Technical Service Bulletin

SUBJECT: CORRECTION TO INSPECTION PROCEDURE FOR TRANSAXLE PROPORTIONAL VALVE CHECK - SERVICE MANUAL REVISION			No: TSB-24-23-005
			DATE: September 2024
			MODEL: Outlander
CIRCULATE TO:	<input type="checkbox"/> GENERAL MANAGER	<input checked="" type="checkbox"/> PARTS MANAGER	<input checked="" type="checkbox"/> TECHNICIAN
<input checked="" type="checkbox"/> SERVICE ADVISOR	<input checked="" type="checkbox"/> SERVICE MANAGER	<input checked="" type="checkbox"/> WARRANTY PROCESSOR	<input checked="" type="checkbox"/> SALES MANAGER

This TSB provides correction to the instruction procedure for the Proportional Valve Check in the Transmission & Driveline section within the applicable Service Manuals.

DF2000C4AA

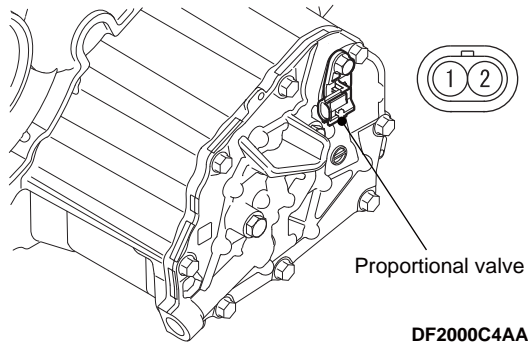
Please use the chart below to replace the page in the affected Service Manuals: Transmission & Driveline, Transaxle, Front Transaxle, On-Vehicle Service, Proportional Valve Check sections.

- Measure the resistance between proportional valve connector terminal Nos. 1 and 2.
Standard value: Approximately 12.1 Ω [fluid temperature: 20°C (68°F)]
- Check the continuity between proportional valve connector terminal No. 2 and body earth.

Standard value: No continuity

2. If the check result is not within the standard value, replace the valve body assembly.

<Corrected>
